**Assessment of the Underground Distribution System
of the Potomac Electric Power Company**

Final Report

Formal Case No. 991

Prepared by Stone & Webster Consultants
For the Public Service Commission of the District of Columbia

Figure 7 Hot (290° F) Secondary Splice Located During Field Inspection

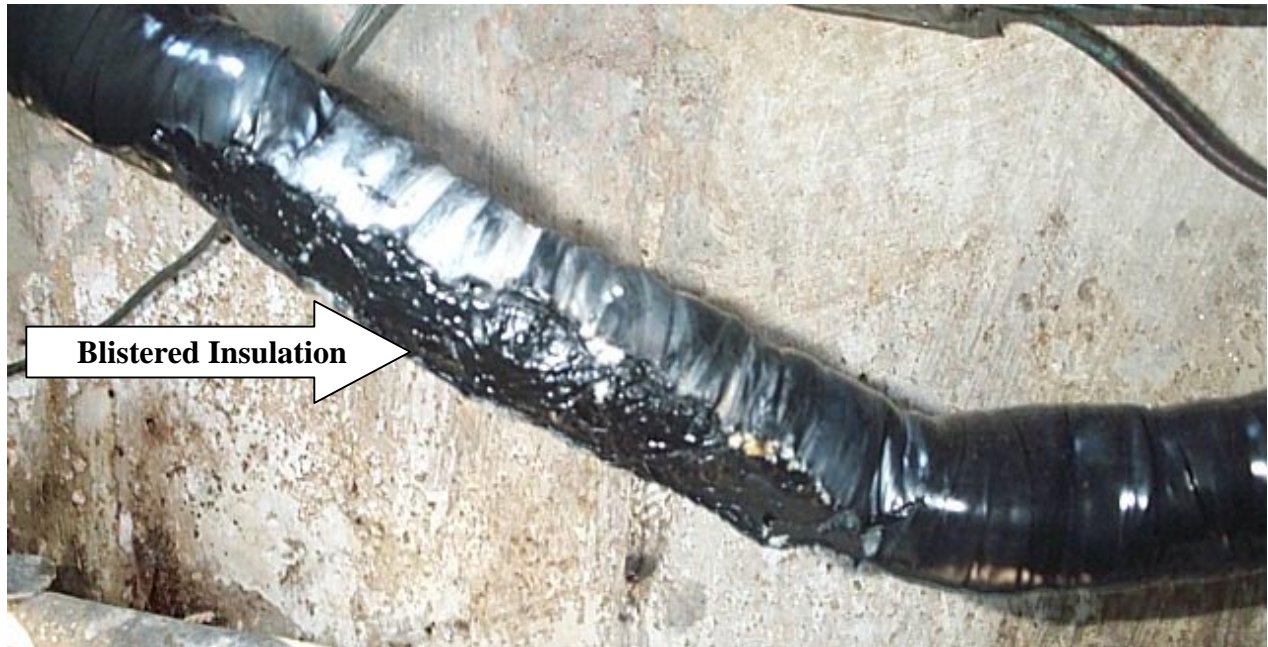
A hot (290° F versus the design maximum of 167° F) 208-volt splice was found at the corner of N and 35th Streets in the Georgetown secondary network system (Figure 7). Bubbling and blistering of the insulation are visible in the picture. The hot splice was called in and repaired by a responding crew. During the repair, the crew found and replaced another splice with deteriorating insulation. This small, crowded manhole contained both 4kV primary and 208-volt secondary cables, and is an example of a situation where a primary fault could propagate into a secondary fault and vice versa.

Figure 9 Terracotta Ducts with Primary and Secondary Cables within a Duct Bank

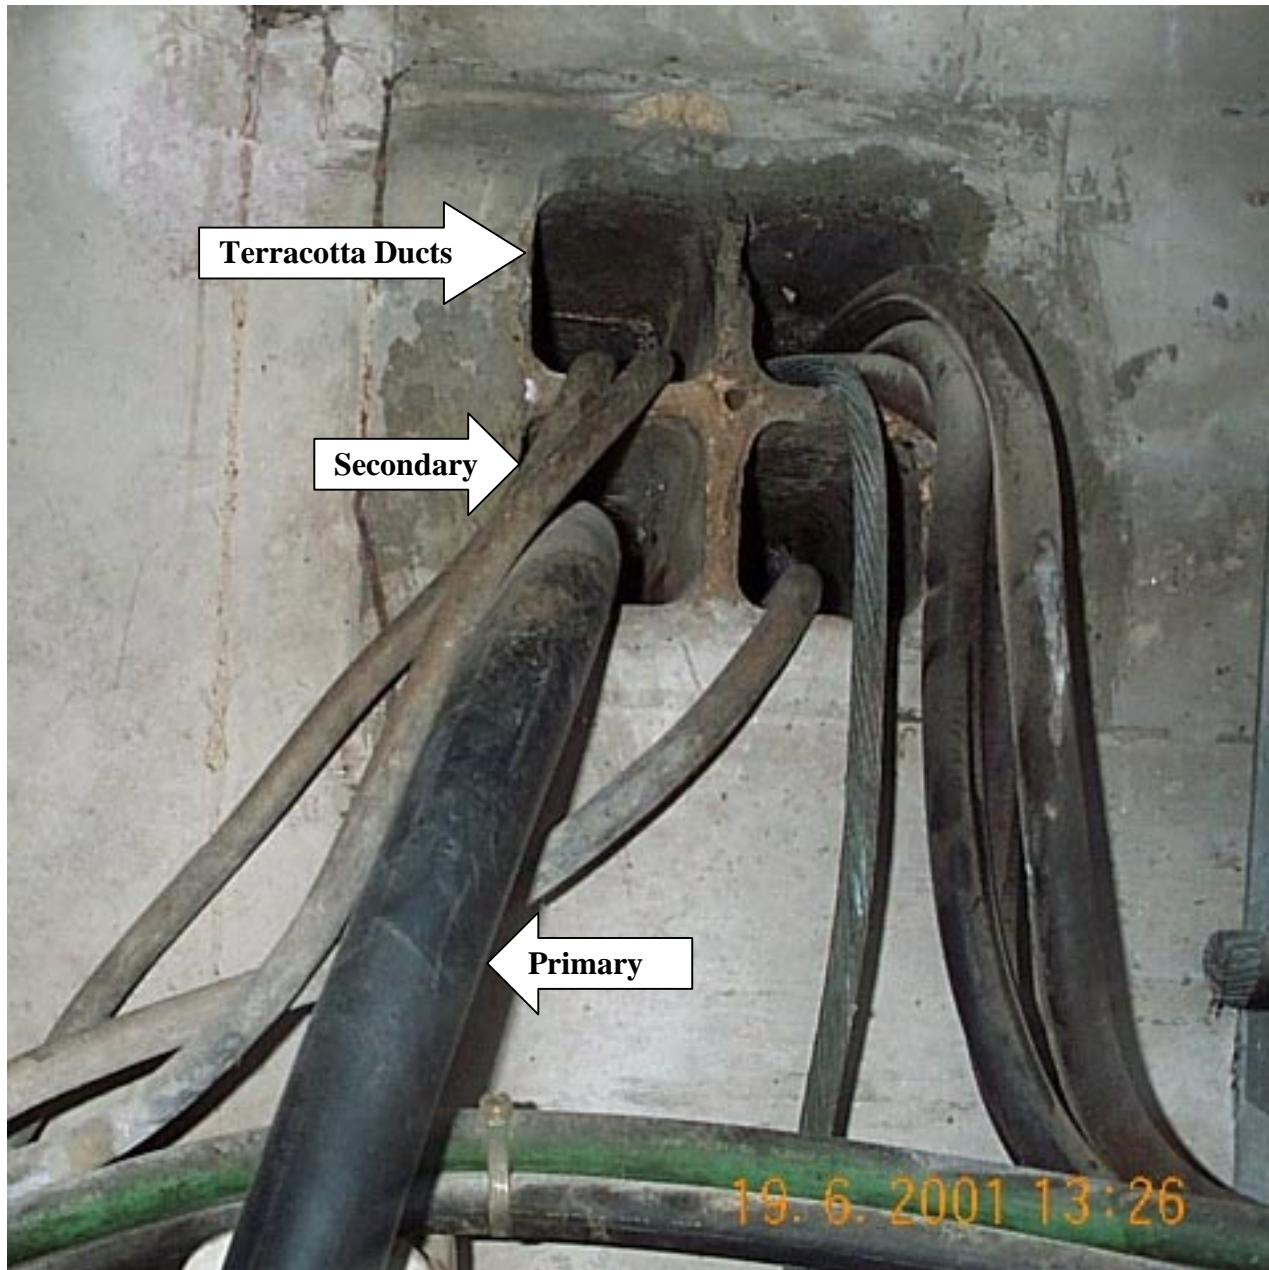
An example of the use of old-style material in Georgetown manholes is terracotta ductwork, shown in Figure 9. In this example, the terracotta tiles form four square duct holes arranged in an overall square. Different numbers of ducts of different cross-section areas are found in different manholes. Although terracotta is a durable material, it is brittle and the joints between tiles can separate, effectively blocking the duct.

Figure 11 Debris Inside a Manhole With a Slotted Cover

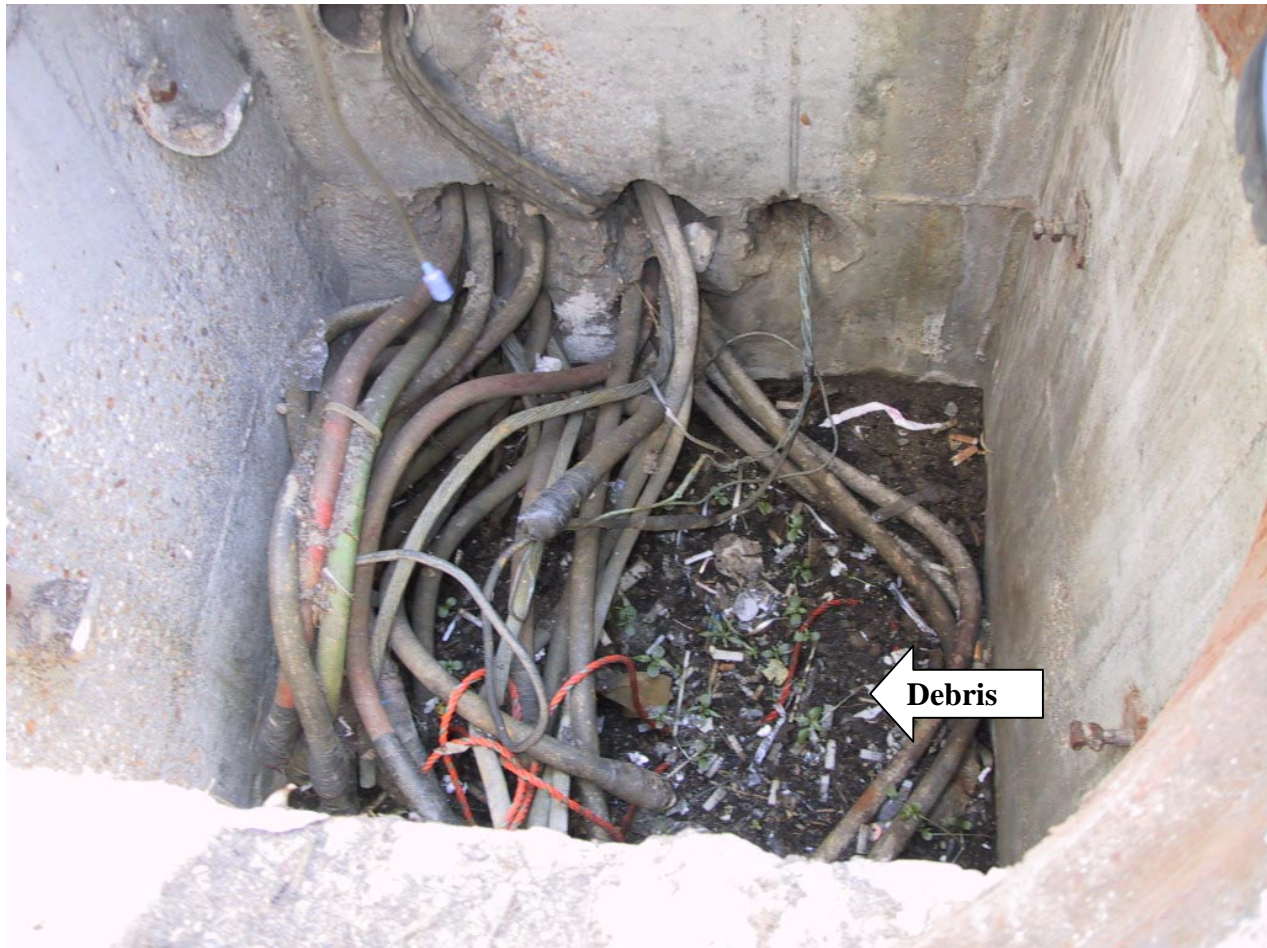
Concern has been expressed about the accumulation of debris in manholes with slotted covers. This concern is justified, as debris was found on the floors of some manholes with slotted covers. Figure 11 shows an example of debris accumulation on the manhole floor. Another example of debris accumulation was observed in a manhole on 33rd Street near Q Street, which had a layer of leaves on the manhole floor.

Figure 14 Crowded Adams Morgan Manhole

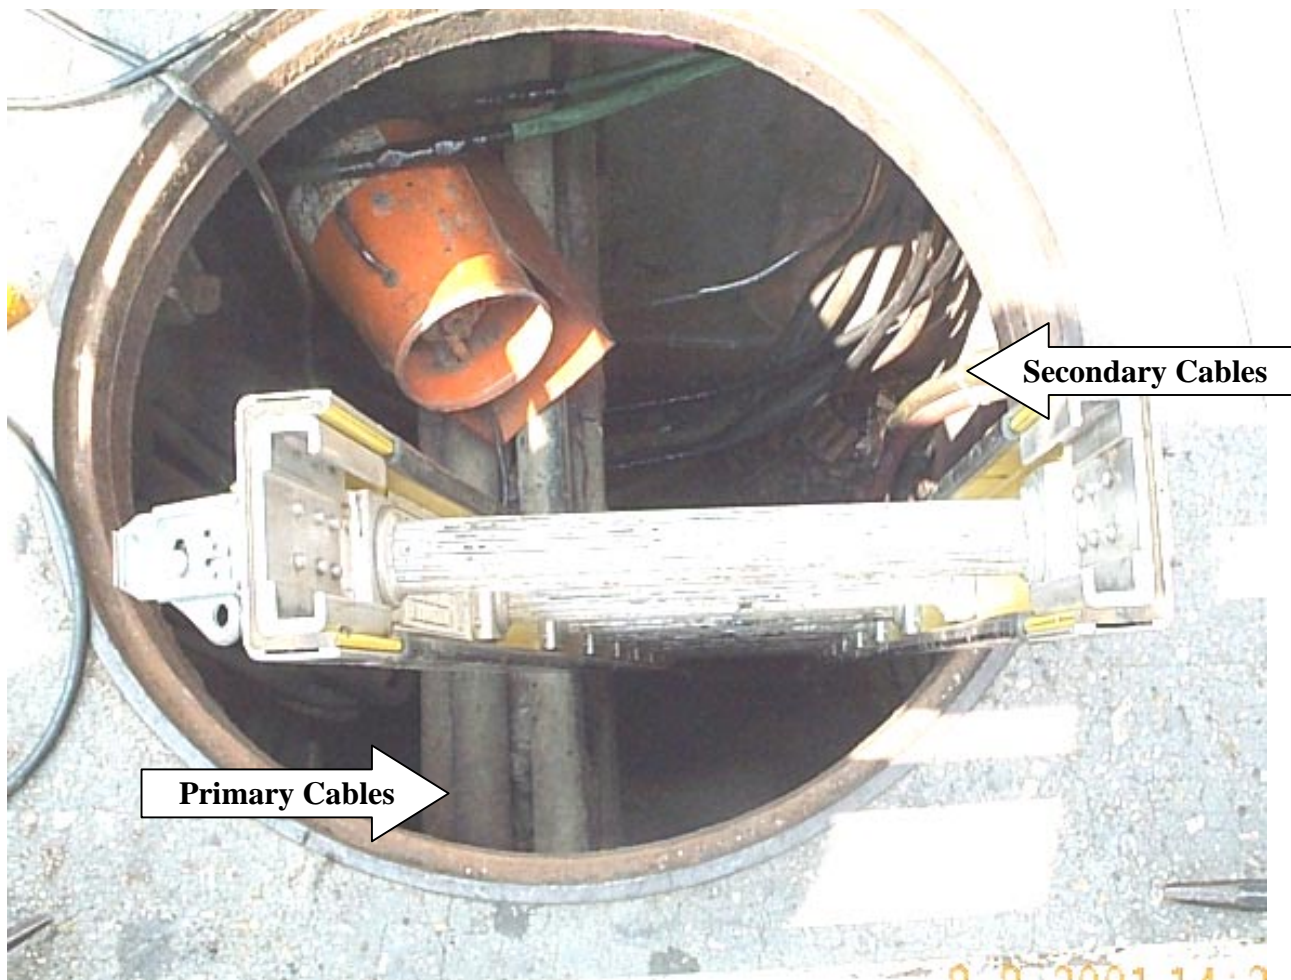
Figure 14 shows an Adams Morgan manhole while the work was in progress. The present need for additional cables further raises a concern regarding the future capacity of the underground system in Adams Morgan. This needs to be resolved by network modeling and analytical prediction of cable loading for present and future years.

Figure 16 Imploded Primary PILC Y-Splice

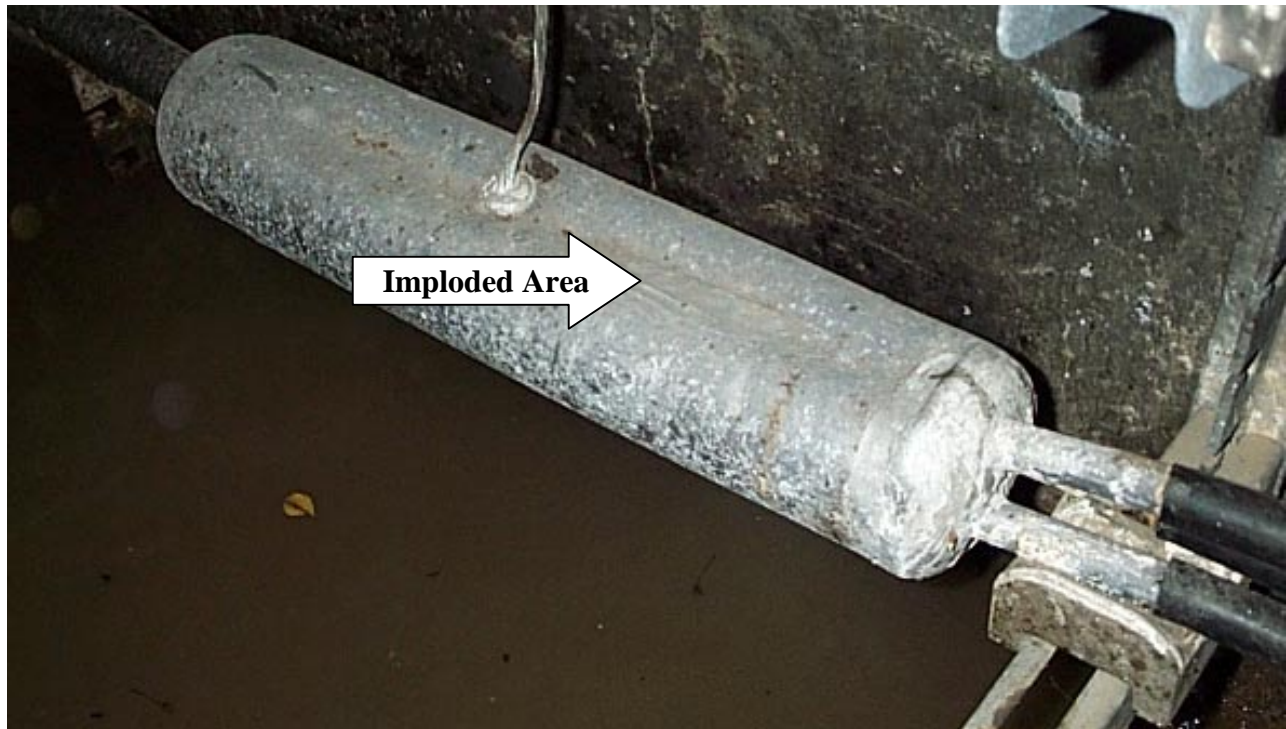
Deficiencies were observed in some of the manholes. For example, two slightly imploded primary cable lead splices were found. When a lead cable is spliced, the splice is filled with a tar-like compound. If insufficiently filled, the lead will partially collapse over time. Figure 16 shows an imploded splice. The lead covering the splice should be cylindrical. In this case, the upper surface of the outside lead is indented, appearing like a groove on the top of the splice. While not an immediate concern for failure, imploded splices should be replaced to prevent premature failure. This is an example of the kind of condition the Pepco manhole inspection program is designed to detect and repair.

Figure 17 Primary Cables with Small Radius Bend and Missing Porcelain in the Saddle

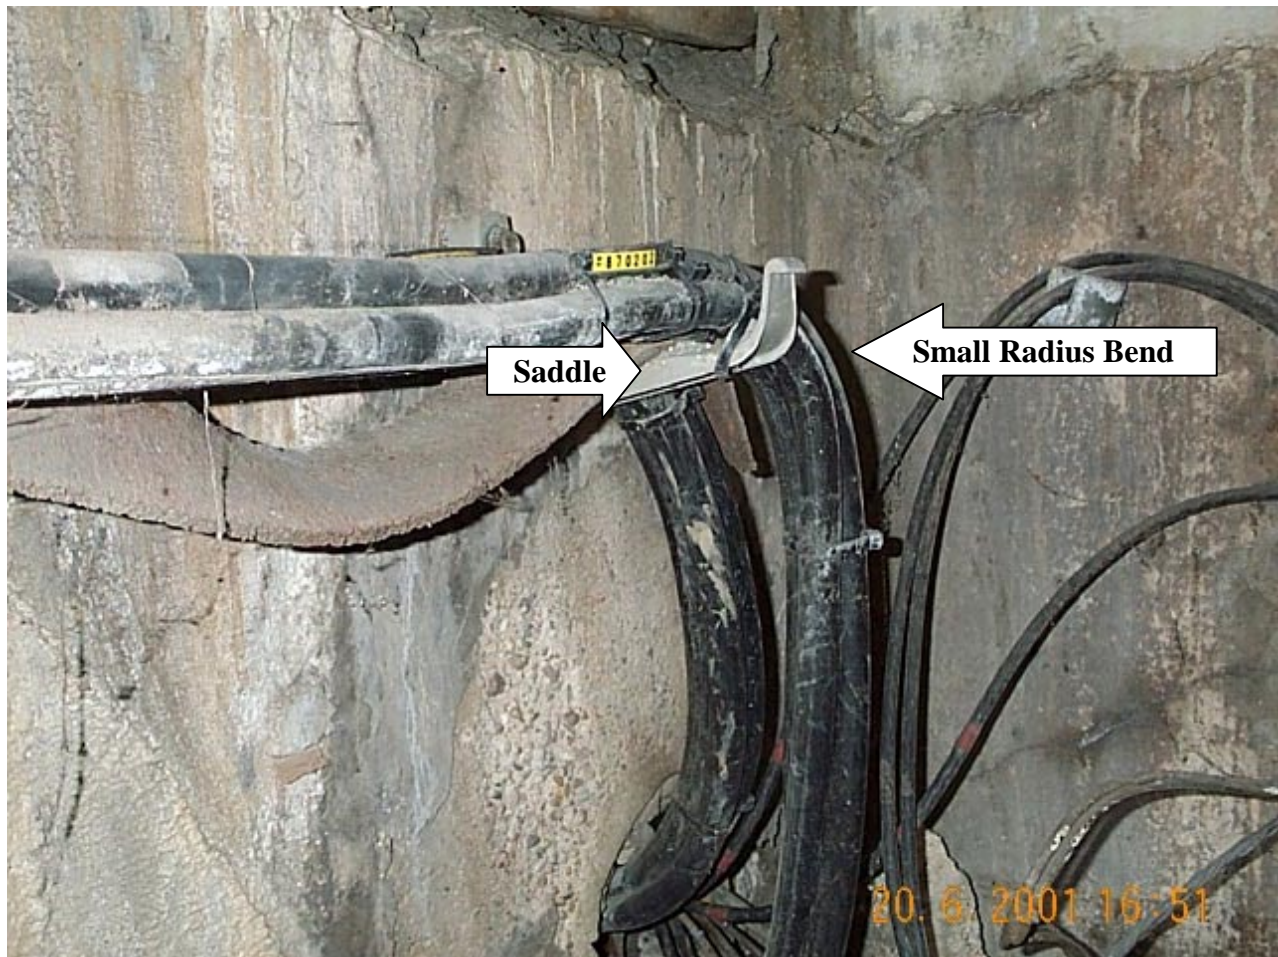
While workmanship is generally very good, problems do exist in manholes anywhere. For example, Figure 17 shows some additional problems observed in a manhole. The primary cable has a small tight bending radius that can lead to problems as the cable heats and cools over its load cycle. Also, the porcelain saddle the cable should rest on is missing. Sliding of the cable over the metal bracket can result in wear on the jacket and possible ingress of moisture and subsequent failure.

Figure 23 Primary Feeders in Substation with Leaking Splice

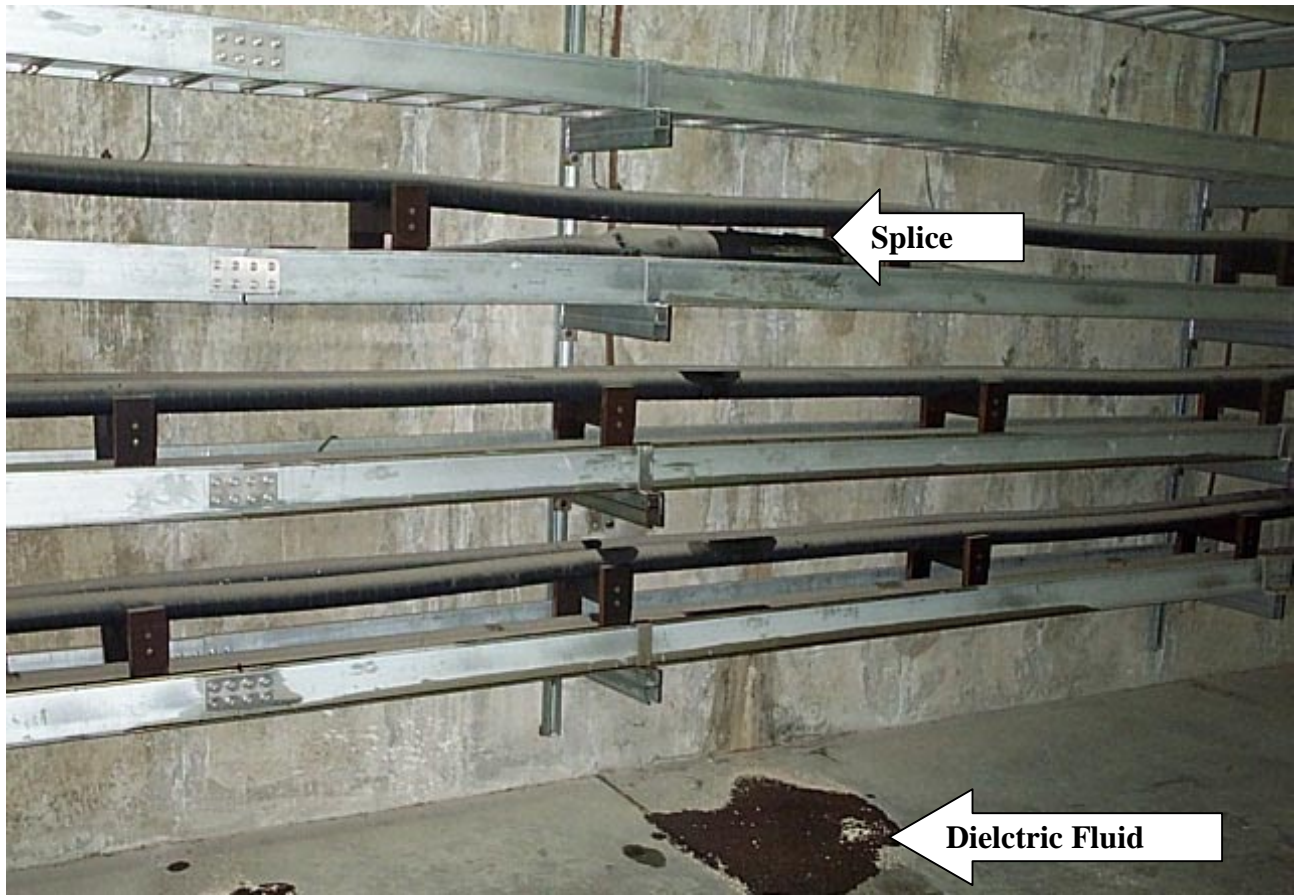
The primary feeders at the substations generally show good workmanship (Figure 22). However, problems do occur, such as the leaking primary feeder splice shown in Figure 23, as noted by fluid spots on the lower cables and floor.

Figure A.3-6 Portion of Low-Voltage Secondary Network System with Limiters Installed in Some of the Low-Voltage Cable Circuits

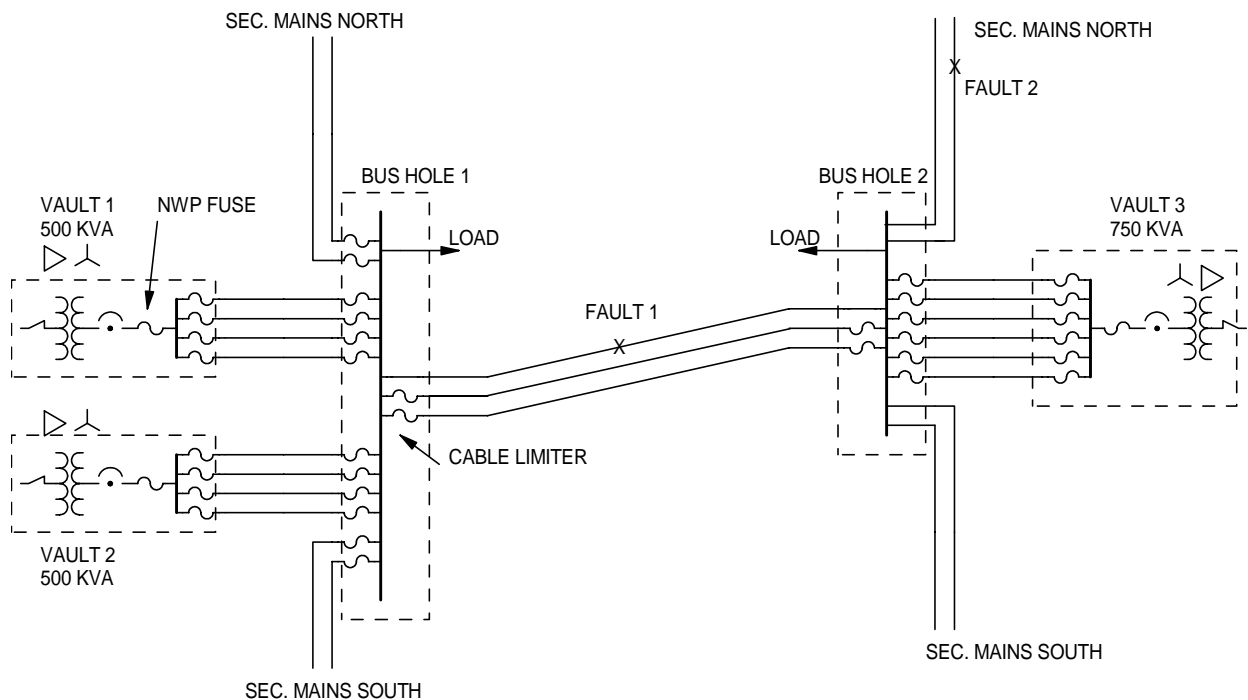
Figure A.3-6 shows the same system except that cable limiters are installed in selective low-voltage cable circuits, similar to the practices on some utilities, including Pepco. Pepco installs limiters in all 500 kcmil cables, but not in 250 kcmil cables when there is just one set in a duct.

When cable limiters are not installed in all cables as in Figure A.3-6, the evaluation of coordination is more difficult. The reason for this is that there are no data sources giving the time for a cable fault to burn clear as a function of current. For example, for Fault 1, there will be significant current in the secondary mains with limiters, and in the cables with limiters between the transformer vaults and the bus holes. The limiter melting times are known, but there is uncertainty about the self-clearing time of the fault in the cable without limiters.

ABB has recommended that Pepco consider evaluating if limiters should be installed in all 250 kcmil cable circuits, irrespective of the available fault current levels.

Figure B.1-1 Bathtub Failure Curves for System Components

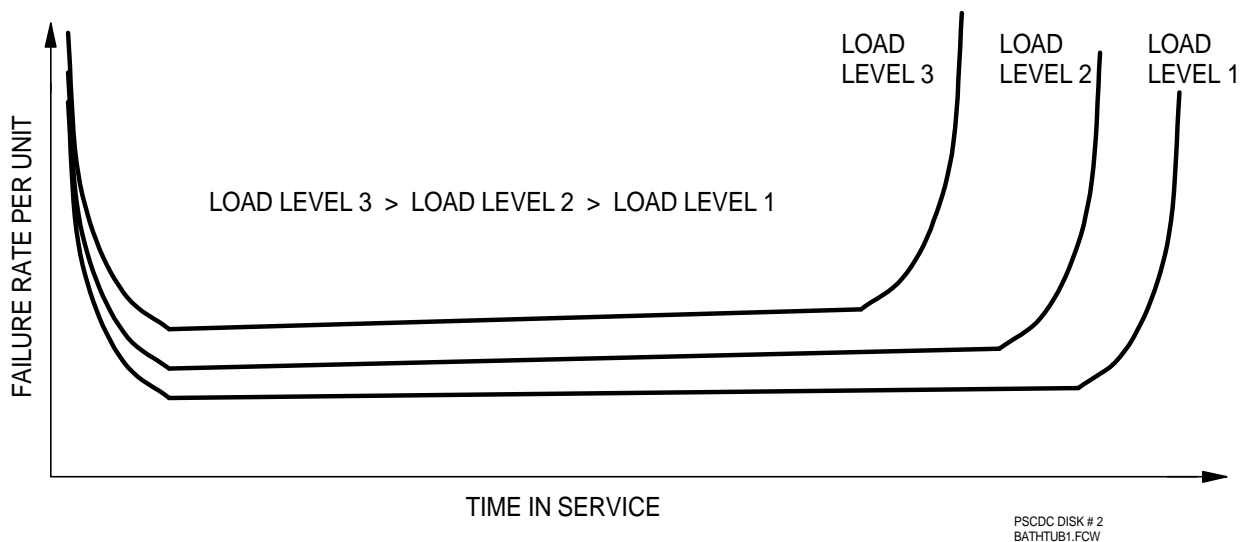
We don’t argue the validity of the typical bathtub failure curve (shown below) that might apply to cables, transformers, and perhaps splices. However, we question the **significance of age solely** on failure rates for cables, splices, and transformers, and at what point in time the curves start to turn up steeply. A more important measure of when to change out a cable, transformer, or a piece of equipment is the failure rate or performance. Figure B.1-1 illustrates how loading might affect the life of an underground distribution system.

In Figure B.1-1, the point at which the failure rate increases rapidly is not known, but in PILC cables and transformers, and perhaps in splices, the turn-up will occur earlier as the loading levels are raised. Other factors, such as submersion in water and chemicals, may affect the point where the turn up occurs. Transformer standards, as well as AEIC standards for paper cables
